**Announcement of Design Number Change for Work Support**  
**(model TNC / model TND / model TC)**

Design number [Model number] has been changed as below for the improvement for environmental resistance.

## Changes in Dimension

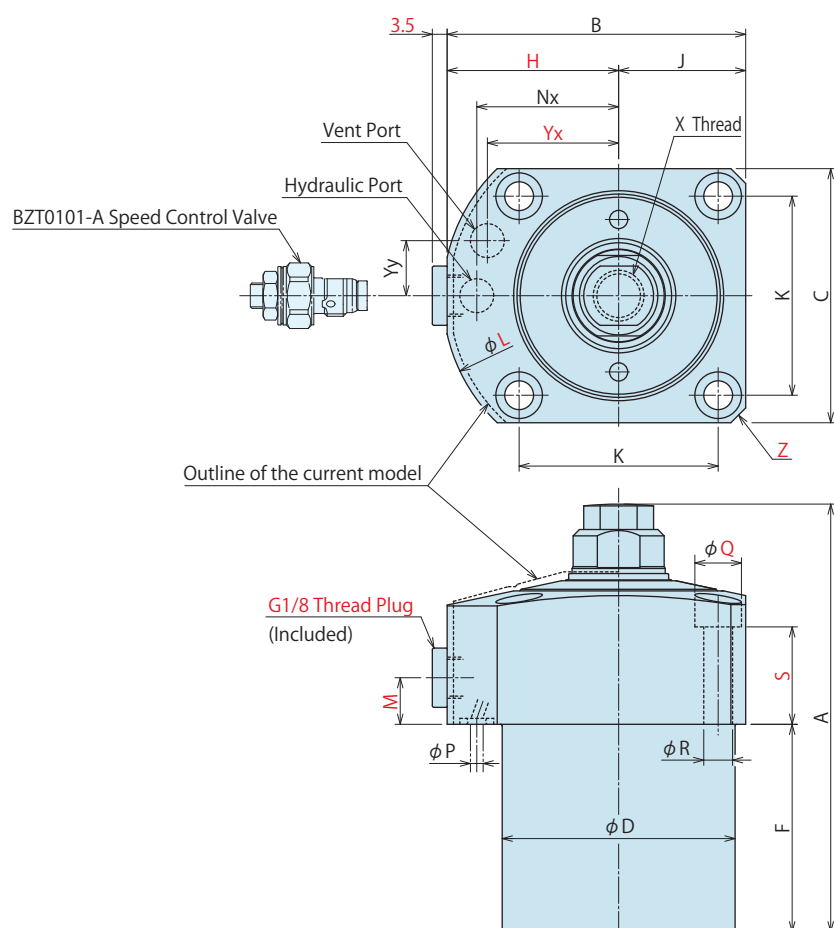
3. External dimensions modified to the vent port to accommodate speed control valves to TC Work Supports. Please refer to attached 'Changes in Dimension' for further details.

Model No.	TC0402 → TC0403	TC0482 → TC0483	TC0552 → TC0553	TC0652 → TC0653	TC0752 → TC0753
H	31.5 → 32.5	35.5 → 36.5	39 → 40.5	–	52 → 51.5
L	68 → 70	73 → 75	80 → 83	–	–
M	–	12 → 11	12 → 11	12 → 11	14 → 11
Q	9.5 → 9	9.5 → 9	–	–	–
S	–	–	–	24 → 23	–
Yx	25 → 26	–	–	–	–
Z	C1 → C3	–	R40 → C3.5	R47 → C5	–
